**Independent Assessment Report (Robinson
Urban Planning)**

Development Application: 14-26 Wattle Street, Pyrmont – D/2019/649**File No.:** D/2019/649**Summary**

Date of Submission:	21 June 2019
Applicant:	Landream Pyrmont Pty Ltd
Architect/Designer:	Tzannes
Developer:	Landream Pyrmont Pty Ltd
Owner:	Council of the City of Sydney
Cost of Works:	\$221,892,000
Zoning:	Zone B4 - Mixed Use (development is permitted with consent)
Proposal Summary:	Concept development application (DA) for Integrated Development under the Water Management Act 2000 (the proposal will require aquifer interference approval and under the Roads Act 1993 being works to a classified road). The application includes a 34.95m high building envelope. Indicative land uses include residential, commercial, retail, child care and recreational facilities.
Summary Recommendation:	This proposal is recommended for refusal.

Figure 21: Reference design showing contravention of the 27m height of buildings standard (Source; Mecone, Clause 4.6 Written Request, Figure 3)

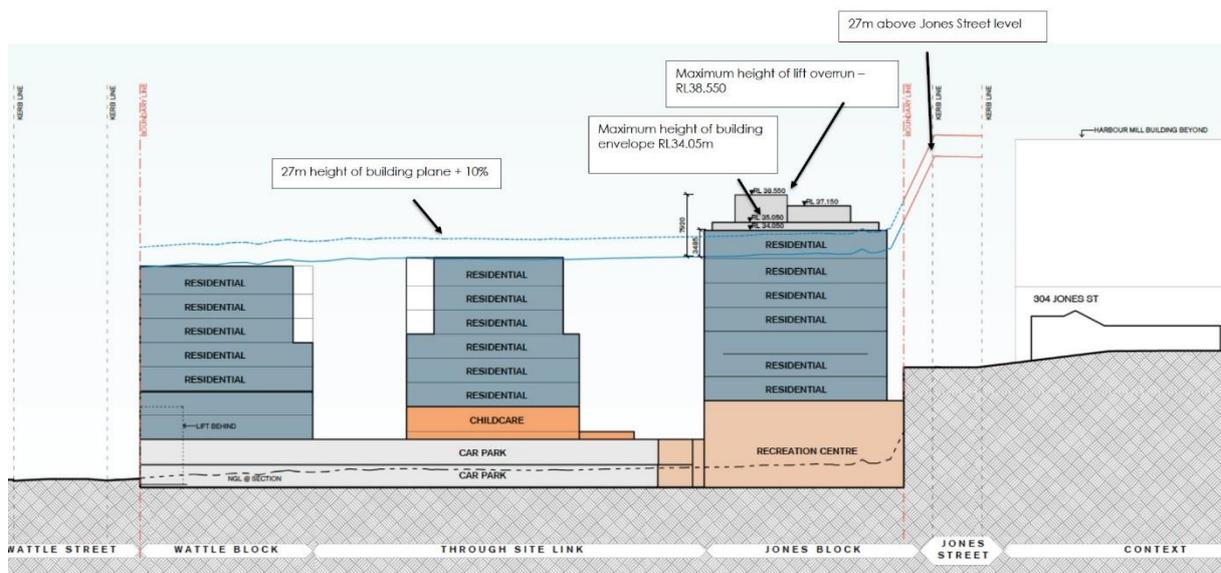
34. The site is subject to a 27m height of buildings standard pursuant to SLEP 2012, clause 4.3. The proposed development has a height of up to 34.95m (+29.4%) to the Jones Block lift overruns and up to 30.88m (+14%) to the Jones Block. The Fig Block, Wattle Block and Mid Block also exceed the height standard, as illustrated by **Figures 21 to 23**.
35. A written request has been submitted to Council in accordance with clause 4.6(3)(a) and (b) of SLEP 2012 seeking to justify contravention of the development standard by demonstrating:
- That compliance with the development standard is unreasonable or unnecessary in the circumstances of the case; and
 - That there are sufficient environmental planning grounds to justify contravening the standard.
36. A copy of the applicant's written request is provided at **Attachment C**.

39. **NO.** The applicant's written request has not stated sufficient environmental planning grounds to justify contravening the 27m height development standard. In particular, the environmental planning grounds in the written request:

Figure 23: Clause 4.6 Written Request Height Plane Study (Source; Mecone, Clause 4.6 Written Request, Figure 2 marked up)

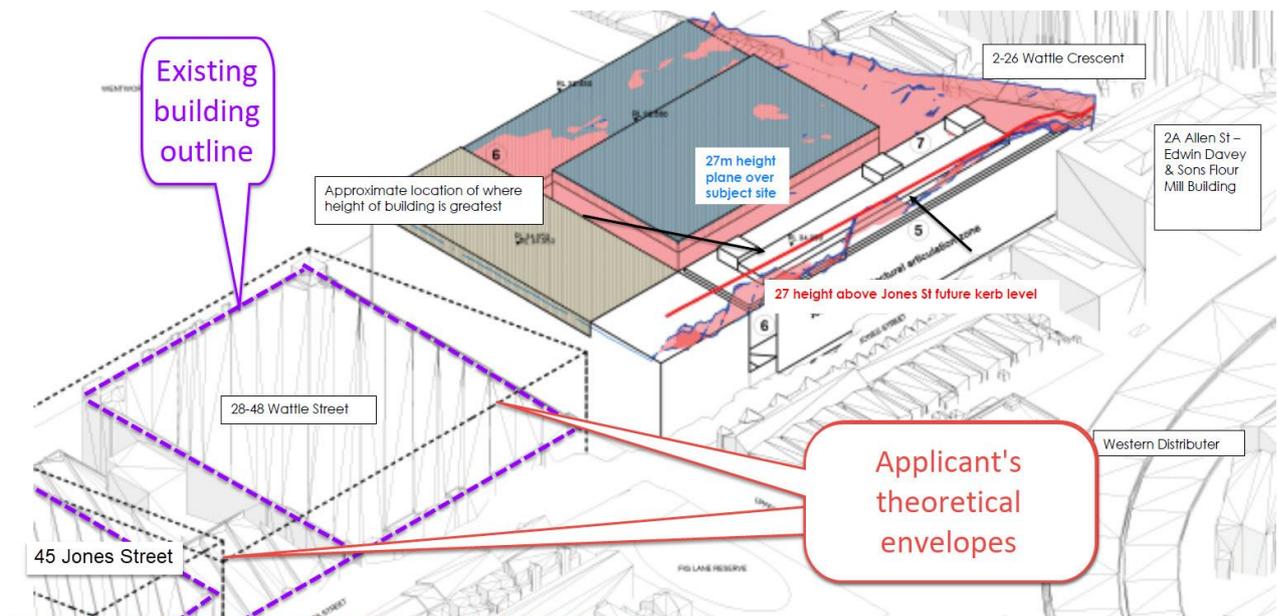
- (a) **28-48 Wattle Street:** The written request refers to a theoretical/future building envelope over the former Winchcombe Carson woolstore at 28-48 Wattle Street as part of the site context (see **Figure 23** which is a mark-up of the height plane study included in the written request). This theoretical/future building envelope is reproduced on the Concept Envelope Plans and Indicative Reference Design Scheme plans. This theoretical/future envelope relies on a flawed assessment of *ground level (existing)* which exaggerates the permitted height. The written request overlooks the heritage listing of the former woolstore and its significant saw tooth roof which would constrain the potential for additional height. The context analysis does not assess whether there is any available GFA/FSR on the former woolstore site. The approved addition at 45 Jones Street (aka 54 Wattle Street) provides a more reliable guide to the scale of development that might be reasonable at 28-48 Wattle Street (see below and **Figure 24**).

- (b) **45 Jones Street (aka 54 Wattle Street):** The written request refers to an approved/future addition at 45 Jones Street as part of the site context (see outline on **Figure 23**). The approved addition (DA D/2011/2126 approved on 7 March 2012), which has not been built, is modest and setback from the existing parapets. At Jones Street, the addition is well below the applicable 33m height standard. Furthermore, 45 Jones Street is approximately 150 metre to the south of the site and the properties have almost no visual connection.

Figure 25: Proposed Storeys: Indicative Reference Scheme - Fig Street Elevation

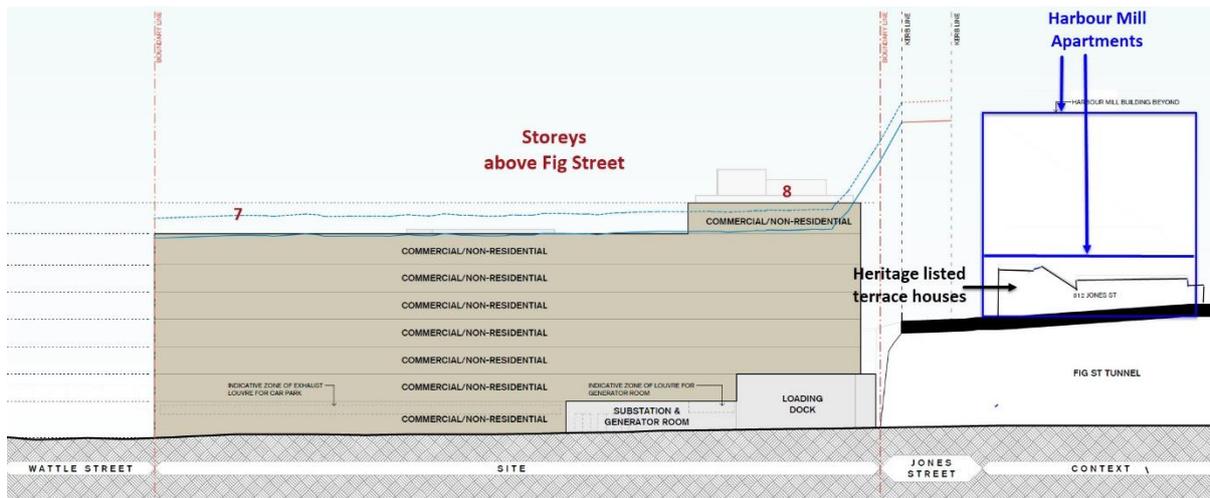
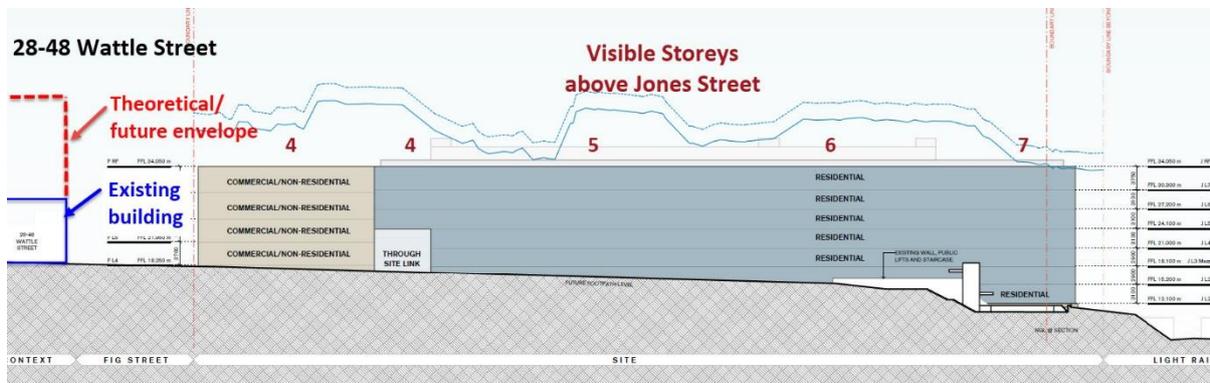
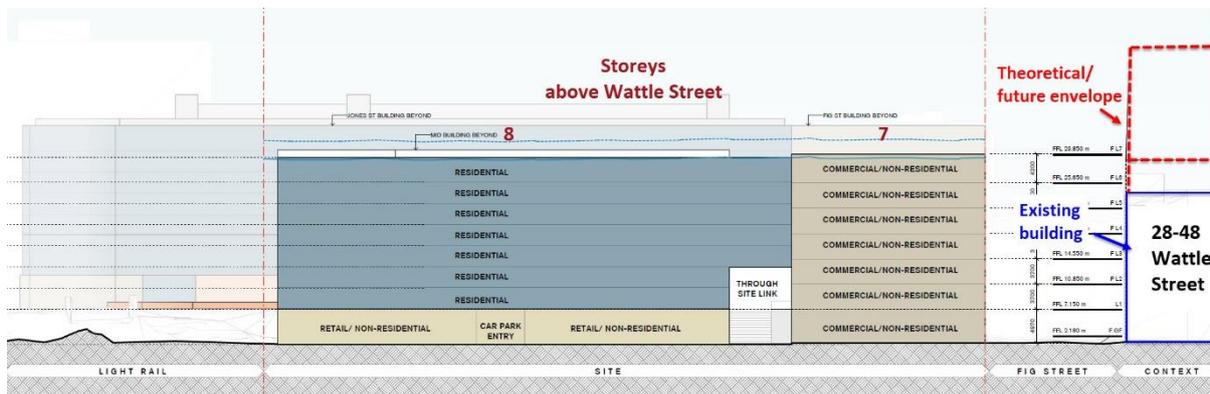
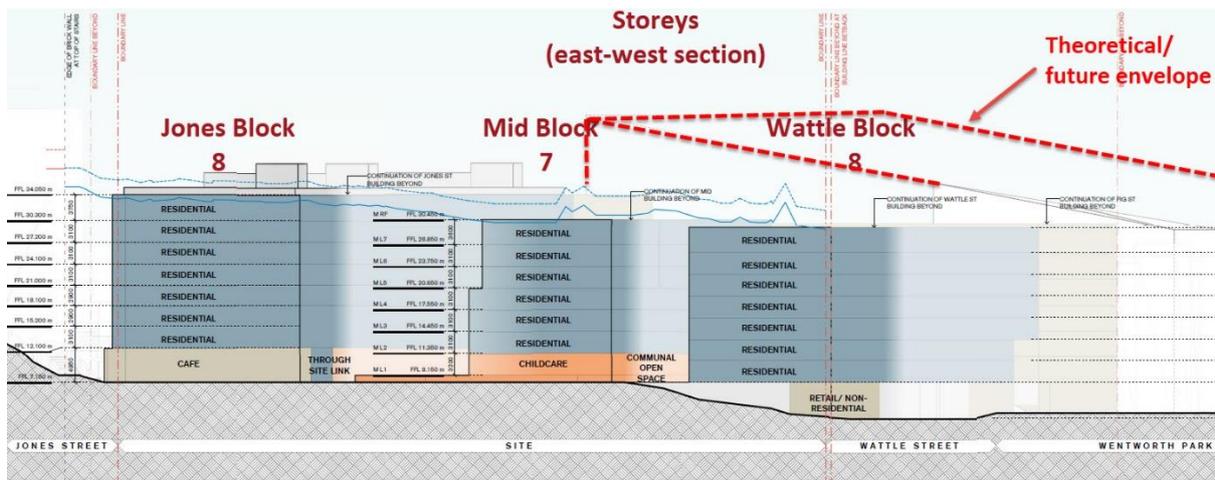
46. The Indicative Reference Scheme shows that the Concept Envelopes can accommodate the following number of storeys (see **Figures 25 to 28**):
 - (a) Jones Block: 8 storeys plus lift overruns (counting the 11.1m recreation centre as 1 storey)

- (b) Mid Block: 7 storeys
 - (c) Wattle Block: 8 storeys
 - (d) Fig Block: 7-8 storeys
47. It is considered that the height of the Jones Block is excessive and inconsistent with the existing scale of nearby heritage items and the neighbourhood character (see above review of the clause 4.6 written request). The Concept Envelope should be lowered to a maximum 3 - 4 storeys above Jones Street (with a setback at the top level). This would necessitate the deletion of at least 1 storey from the Concept Envelope.

Figure 29: Jones Street Footpath Section (Source: Oculus DA1-9008)

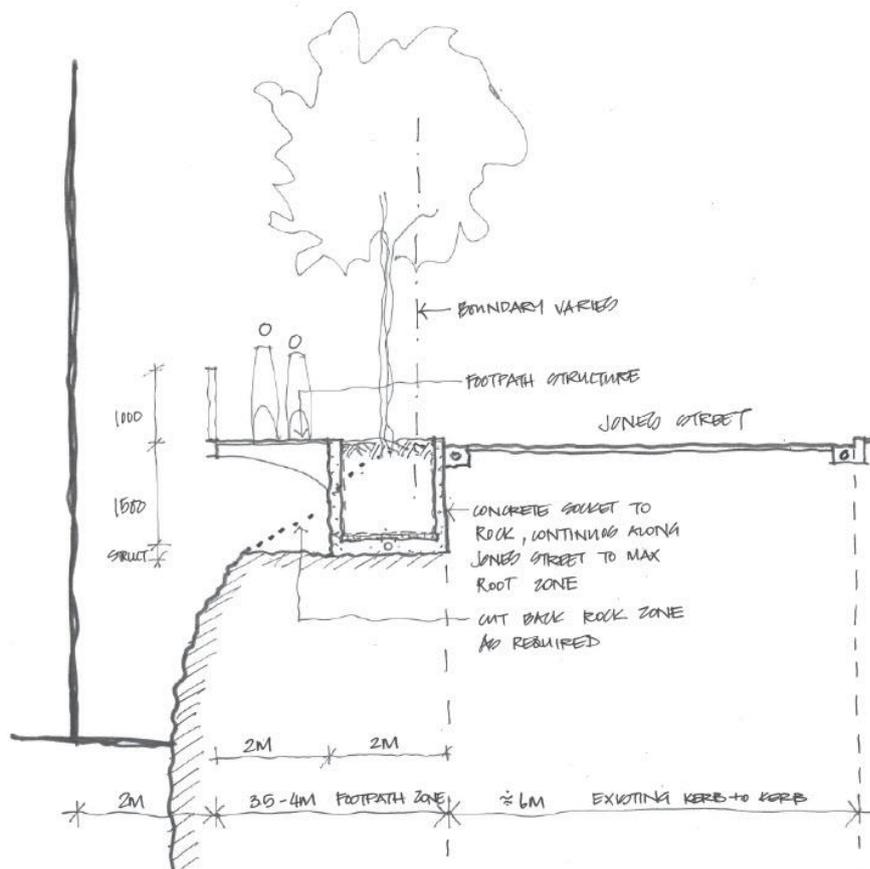
- 62. Council's Urban Designer and Senior Public Domain Coordinators have advised that the Concept DA includes inadequate information on activation of the proposed through site links and public domain improvements to Jones Street. The Concept Envelopes show a "Potential Jones Street Footpath Zone" straddling the cliff, partly on the site but mostly within the Jones Street road reserve. No more details are included in the Concept Envelope Plans, with some limited information shown in the Landscape Principles Diagrams by Oculus indicating that extensive civil works would be required to achieve the proposed tree planting and cantilevered footway (as illustrated by **Figure 29**).
